Access Compliance Report

Public Rights-of-Way

(Curb Ramps)

Intersection ID: 10021397	Main Street: BLUEBIRD_DR	Cross Street: N/A	Location: SE
ADA ID: FE63E7026954	Ramp Type: Perp	Initial Pass/Fail: Fail	Overall Compliance: No
		Severity Score: 12.5

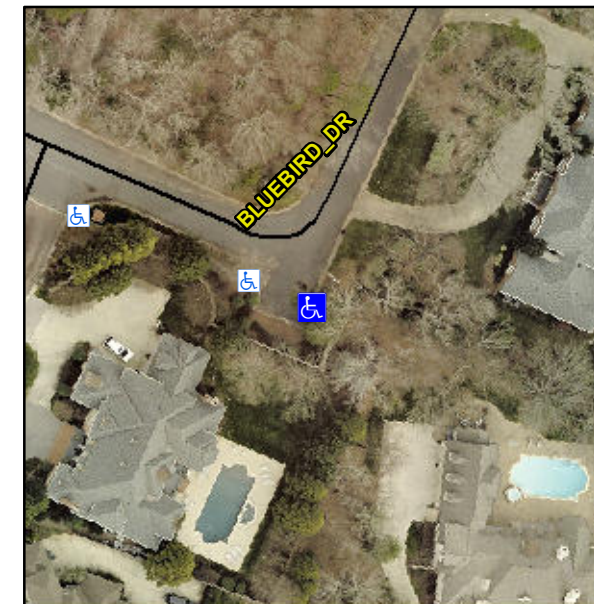
R304.2.2

Compliance	Description	Data	Compliance	Description	Data
N/A	Ramp Length (in)	96.0	No	Ramp Slope (%)	10.7
Yes	Ramp Width (in)	48.0	Yes	Ramp XSlope (%)	0.6
N/A	Flare Type LT	N/A	N/A	Flare Type RT	N/A
N/A	Flare Slope LT (%)	N/A	N/A	Flare Slope RT (%)	N/A
N/A	Flare Traversable LT?	N/A	N/A	Flare Traversable RT?	N/A
N/A	Landing Length (in)	N/A	N/A	DWS Provided?	N/A
N/A	Landing Width (in)	N/A	N/A	DWS Contrast?	N/A
N/A	Landing Slope (%)	N/A	N/A	DWS Length (in)	N/A
N/A	Landing X Slope (%)	N/A	N/A	DWS Full Width?	N/A
N/A	Landing Curb? (Y/N)	N/A	N/A	DWS Offset (in)	N/A
N/A	Shared Landing?	N/A			
N/A	Gutter Ponding?	N/A	N/A	Gutter Slope (%)	N/A
N/A	Gutter Lip Ht (in)	N/A	N/A	Gutter X Slope (%)	N/A
N/A	Painted X Walk1?	No	N/A	Painted X Walk2?	N/A
	X Walk 1 Direction	To NW		X Walk 2 Direction	N/A
N/A	X Walk 1 Width (in)	N/A	N/A	X Walk 2 Width (in)	N/A
	X Walk 1 Slope (%)	1.5		X Walk 2 Slope (%)	N/A
	X Walk 1 X Slope (%)	0.7		X Walk 2 X Slope (%)	N/A

Remove & Replace Entire Ramp.
